# Accessibility Evaluation

## Monroe County Polling Location

**Unionville Elementary**  
**8144 E State Rd 45**  
**Unionville, IN 47468**

**Inspection Date: 03/17/2026**  
**Inspectors: Michael Bird**

### Finding: 2

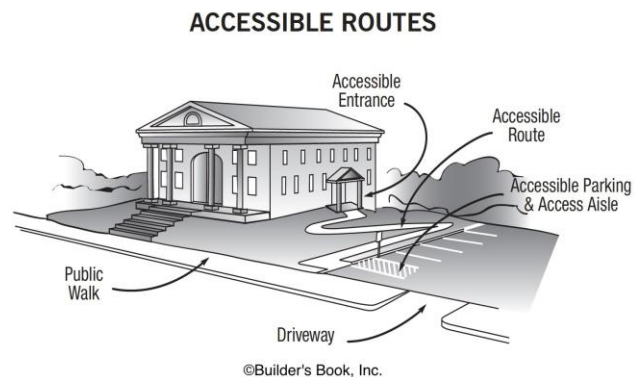
The access aisle is not located on an accessible route of travel to the accessible building entrance. An individual parking at the farther accessible space must enter the vehicular way to reach the curb ramp.

Place cones to create a protected path of travel from the farther access aisle to the closer access aisle and the curb ramp.
